July 1, 2013

Radnor Township Board of Commissioners
301 Iven Avenue
Wayne, PA 19087

I offer the following comments on the materials presented to the Commissioners as included in the materials from the June 24, 2013 meeting.

Hydrograph showing cumulative effect of detention basins in a watershed

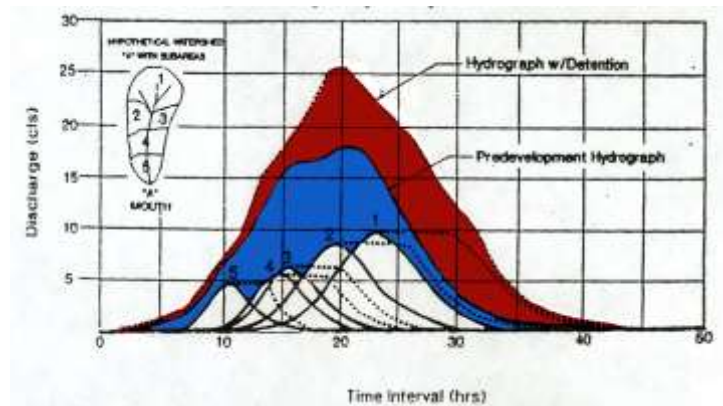
The net effect of detention basins operating in a watershed is to further compound flooding problems. The releases from the basins extends the time over which peak flows from tributaries and detention systems merge, causing an increase in instream volume over a longer period of time.^{viii} The result is that downstream flooding is exacerbated -- flood flow is increased and extended. And the end result can be more flooding and flood damages over a longer period of time.

Detention basins only focus on the peak flow of runoff. Detention basins are designed to collect and hold stormwater for a period of time and then release it directly into the local stream through a pipe sized to pass flows at what are calculated to be pre-development, or pre-determined, peak rates. Detention basins fail to address the increased volume of runoff or the combined peak flow of runoff that enters streams from detention basins and development.

The detention-based approach to addressing stormwater runoff causes a greater volume of water to be discharged to stream systems over a longer period of time and usually at a greater velocity than is the natural condition. Detention basins do nothing to decrease the greater quantity of runoff from a developed site or watershed. Despite the fact that the pre-development peak rate of runoff may be maintained (or even reduced), because there is an increasing VOLUME of runoff, the detention basin is directly contributing MORE water to our streams over a LONGER period of time thereby increasing and extending the peak flow in the creek and that is imposed on communities.
